RE: Bowman Wind, LLC
Bowman Wind Project – Bowman County
Siting Application
Case No. PU-21-121

Bowman Wind, LLC (Bowman Wind) provides this letter in response to the July 22, 2021 letter from the North Dakota Game and Fish Department (NDGFD) to the North Dakota Public Service Commission (Commission) regarding the Bowman Wind Project (Project). In particular, we will address the four recommendations made by NDGFD on the final page of its letter.

Figure 1 - Turbine locations associated with FIDs 3, 11, 16, 37, and 77

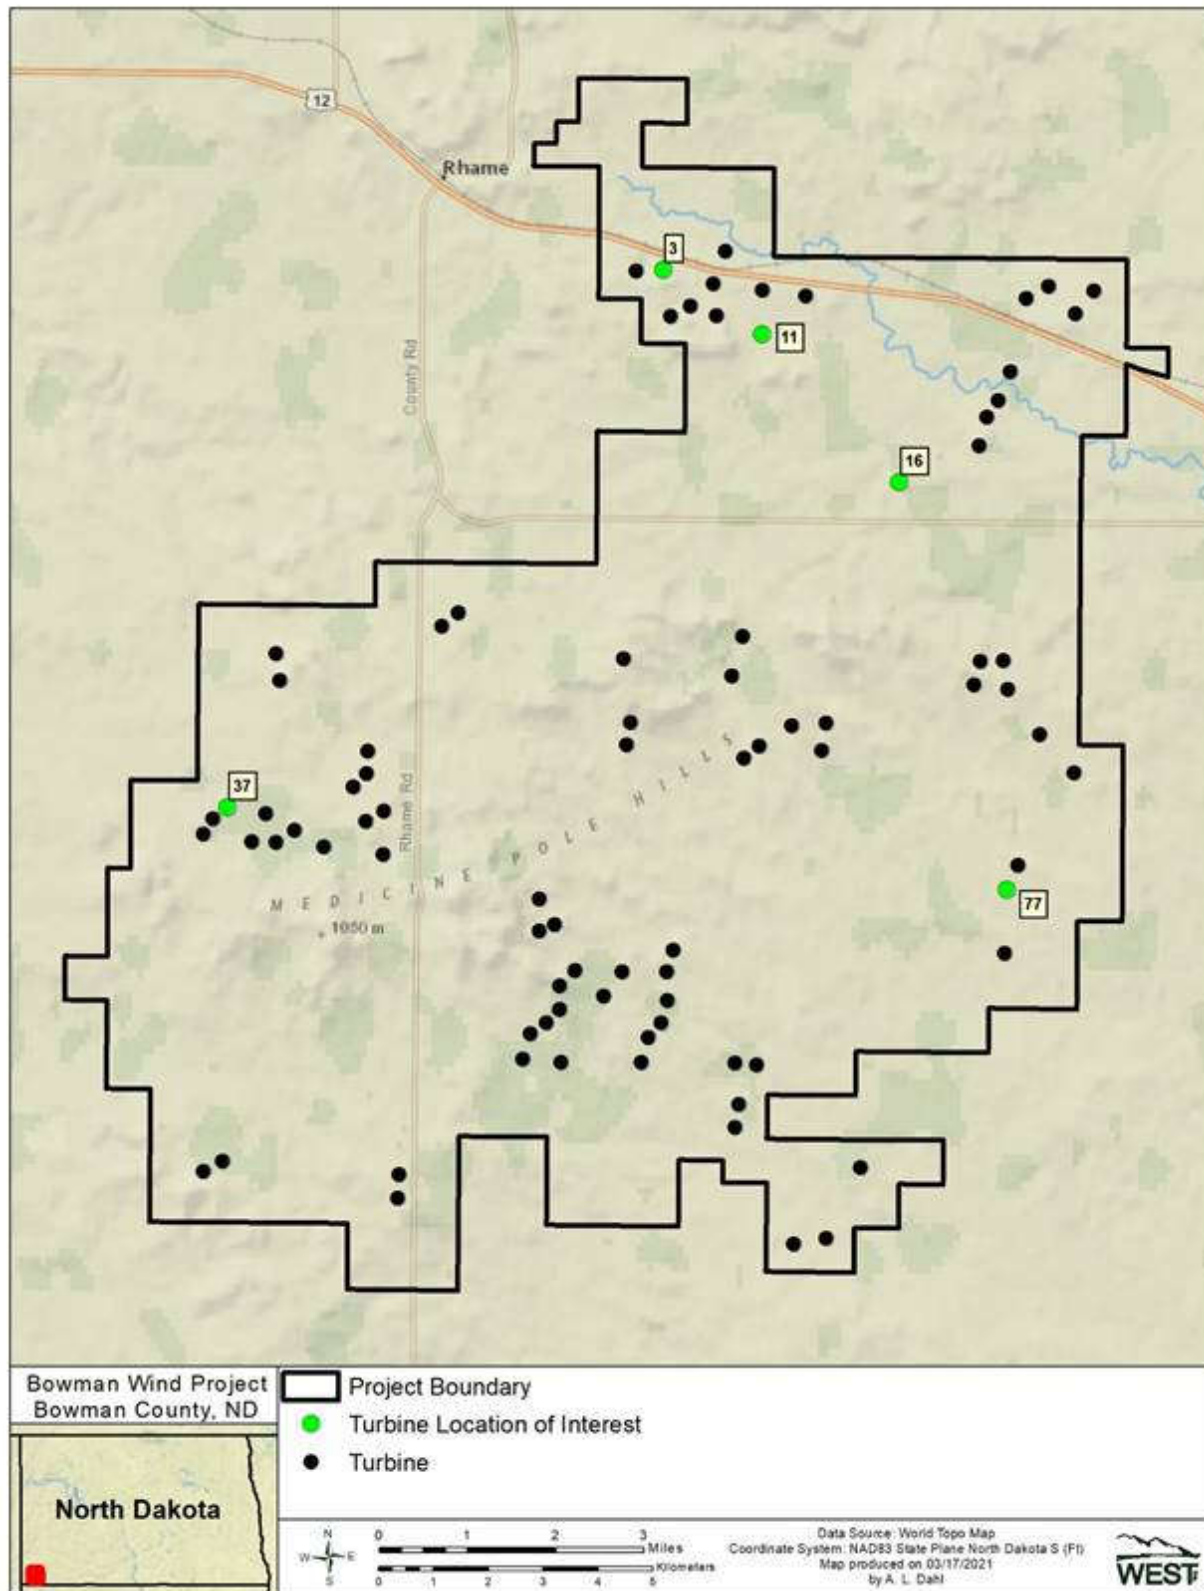
1. Turbines 3, 11, 16, 77, and 37 from layout 59 (no turbine number was attached to that data set, so these are the field IDs... hopefully that makes sense). We have identified these turbines as being on native prairie.

Based on the native prairie/grassland assessment, turbines with FIDs 3, 11, 16, 37, and 77 (Figure 1) were located in areas identified as previously broken grasslands for the following reasons:

- Grasslands within the Assessment Area of turbines FID 3, 11, and 37 were identified as broken based on the NDGF Native layer, historic aerial imagery (1957-1962) that showed evidence of tillage, and results of the field assessment which indicated the presence of rock piles, vegetation in straight lines, and dominance of non-native planted species (i.e., smooth brome grass and alfalfa), which all indicate previous tillage.

- Grassland within the Assessment Area of turbine FID 16 were identified as broken based on not occurring within the NDGF Native layer, recent aerial imagery that indicated disturbance and degradation in 2019 and 2020, landowner confirmation, and results of the field assessment which indicated the presence of rock piles, vegetation in straight lines, and dominance of non-native planted species (i.e., smooth brome and *Poa* spp. grasses), which all indicate past tillage.

- Grassland within the Assessment Area of the turbine FID 77 was identified as broken based on not occurring within the NDGF Native layer and historic aerial imagery that showed evidence of tillage (1957 -1962).
